CONTRACT, LEASE, AGREEMENT CONTROL FORM

Description of: CEW SOUTH APRON REHABILITATION

CHANGE ORDER FORM

Date: 3/11/2024 Contract No.: C24-3928-AP Change Order No.: 01

PAVING PLAN - PHASE 2

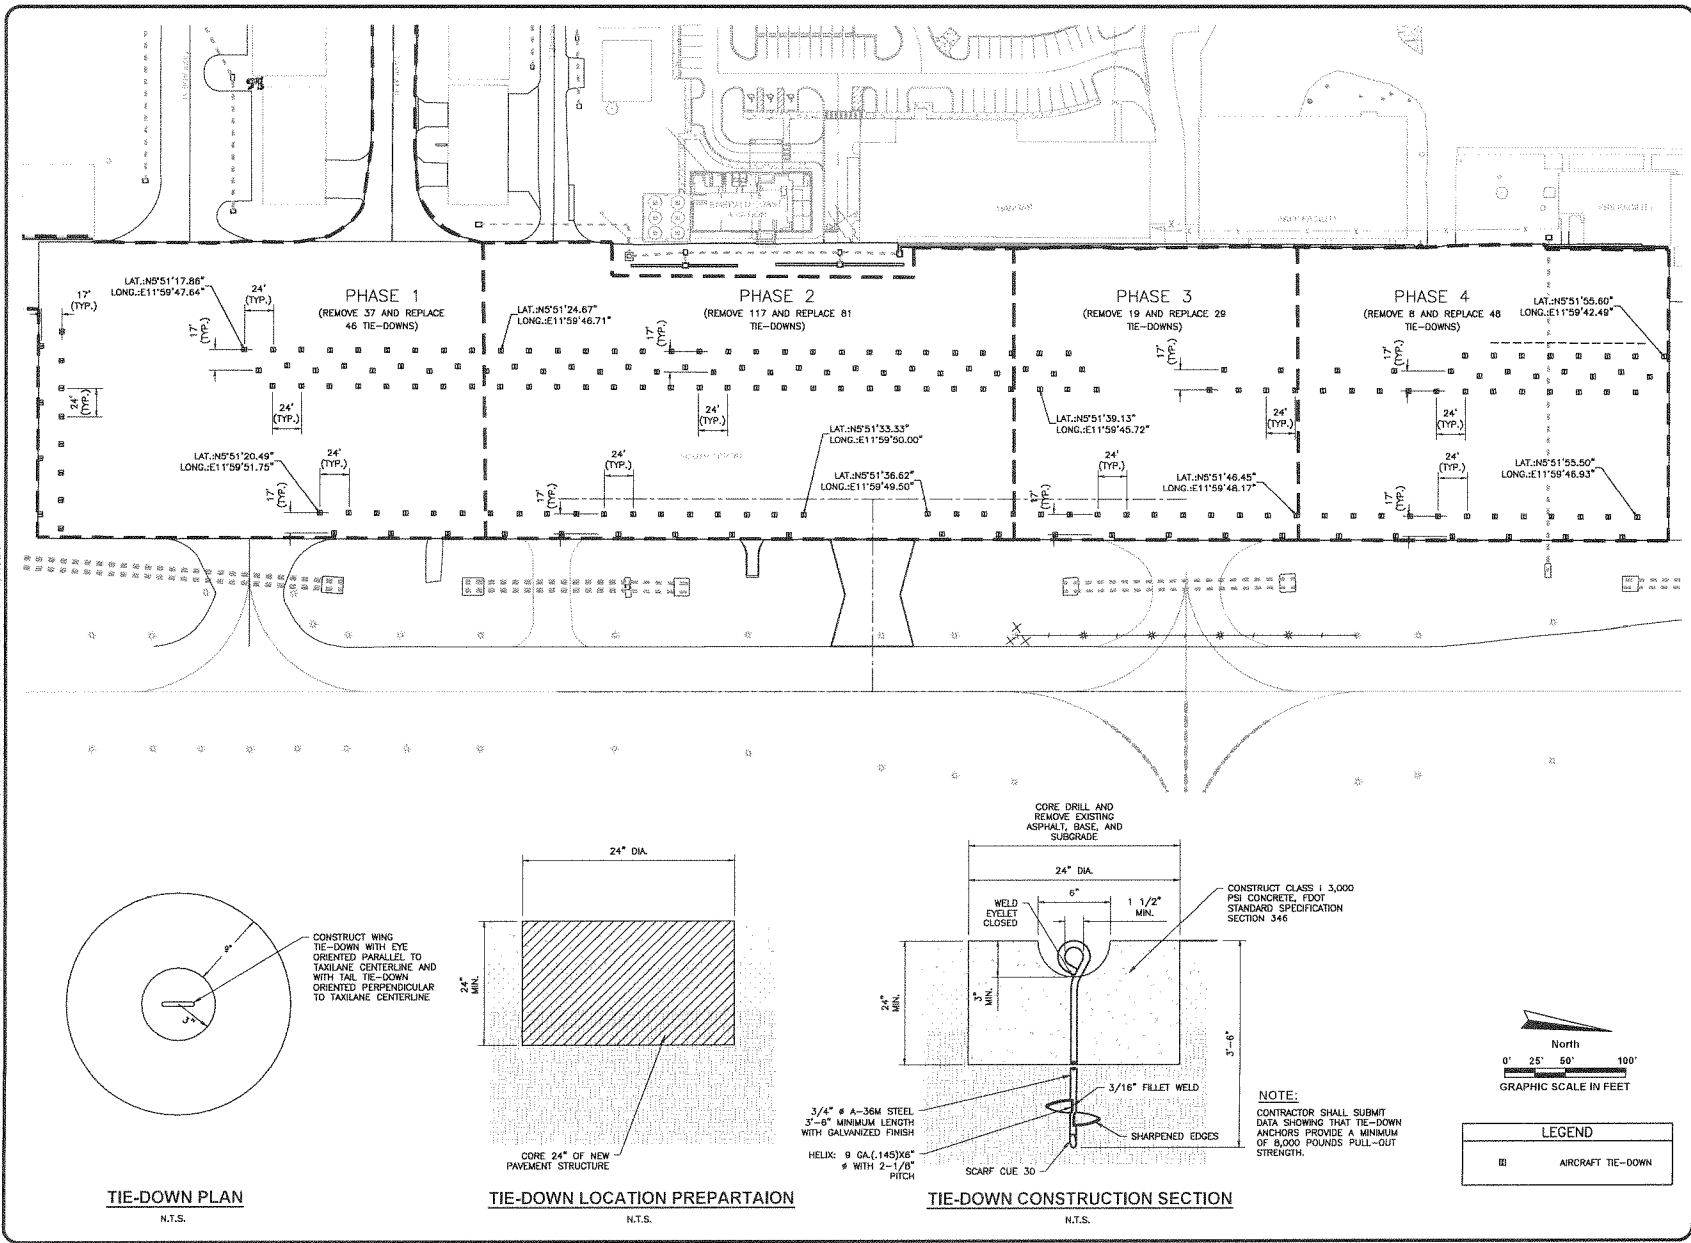
REVISIONS:			
NO.	DATE	BY	DESCRIPTION
1	01/13/24	MAB	NEW CONNECTOR
2	02/13/24	CAP	WORK DIRECTIVE #1
3	02/22/24	MAB	CHANGE ORDER #1

**TIE-DOWN ANCHOR
PLAN & DETAILS**

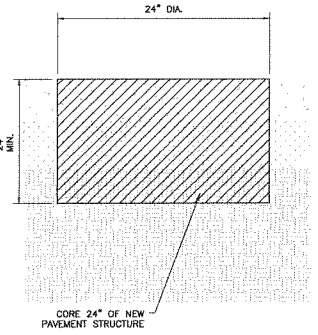
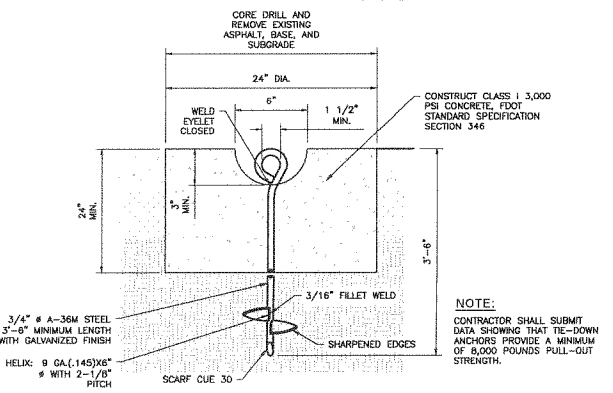
1. ADDED ADDITIONAL SPOT ELEVATIONS AND COORDINATES.

REVISIONS:			
NO.	DATE	BY	DESCRIPTION
1	01/13/12	MAB	NEW CONNECTOR
2	02/13/12	CAP	WORK DIRECTIVE #1
3	03/22/12	MAB	CHANGE ORDER #1
